From: Harris, Matthew (Ecology Officer)
Sent: Monday, August 10, 2026 16:35
To: Burrows, Lydia (Planning Officer) <Lydia.Burrows@newport.gov.uk>
Subject: RE: Planning Consultation Request for case ref: 26/0611

3D - PROPOSED

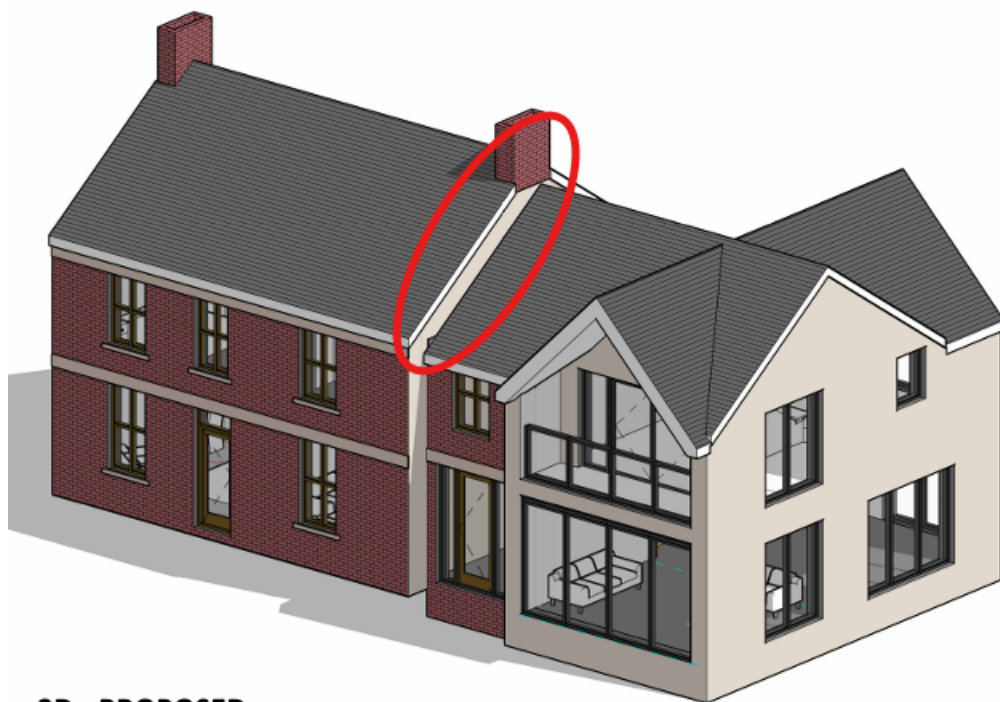
I have a concern in that the report seeks to emphasise that the single-story annex was the sole focus of the survey, and not the main house itself. For example in the summary we read *'If the scope of work increase to include the main house, further survey effort will be required to determine any potential impact on bats.'* Similarly, in section 6.2 it is stated *'Contractors will be made aware that no works to the main house will be undertaken, including the removal of the eastern gable end bargeboard or any ridge or roof tiles to facilitate the new development. If during the course of works it becomes evident that works to the main house are required, advice will be sought from a qualified ecologist'*. However, it is clear from the elevation diagrams that the tie-in of the new two-storey annex will run very close to the barge-boards of the main house:

In my view, the bat survey would have benefitted from a survey of the main house, because if a potential access point or roost feature were present in the barge-boards of the east-facing elevation, then there is every chance that construction of the roof of the new annex would cause disturbance to that roost feature. However, I accept that the report was produced on the basis that there would be no works to the roof or roof features of the main house, and that contingency measures are proposed as above in the event that this should change, so provided the implementation of these measures is secured by planning condition, I have no objection.
